Location of Construction: 856 Brighton Ave	Owner: The Breakwater School	Phone: 772-8689	Permit No: 981252
Owner Address:	Lessee/Buyer's Name:	Business Name:	Permit Issued NOV 2 1998 CITY OF PORTLAND Zoning Approval: 259-2-1
Contractor Name: The Thaxter Co.	Address: 55 Bell St Ptd, ME 04103	Phone: 878-5553

RE: Breakwater School - 856 Brighton Avenue

PROJECT
Breakwater School
856 Brighton Avenue
Portland ME 04102

Addendum

SUMP PUMP PIPING DETAIL

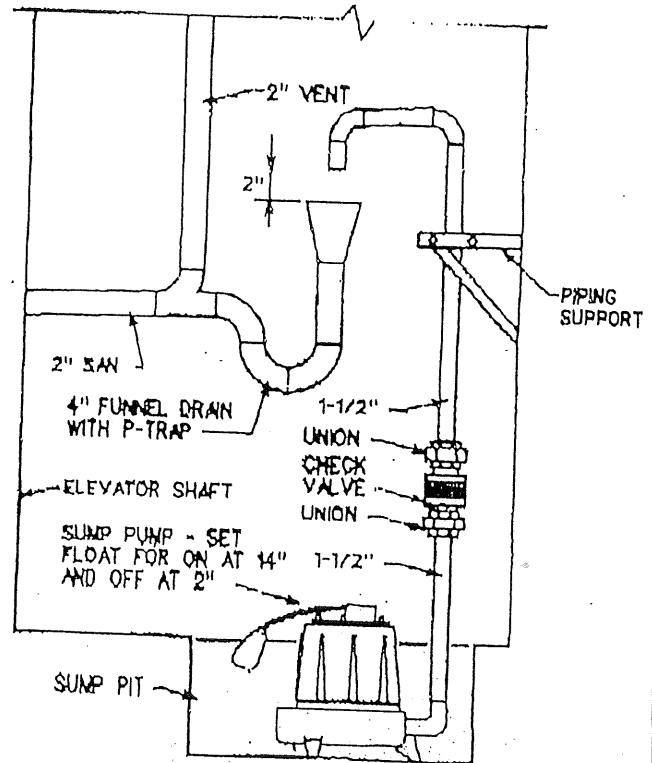
Add 2 inch drain line from elevator sump to connect to new 3" san. waste line at new addition. Provide and install sump pump. (See enclosed revision SKM-1)
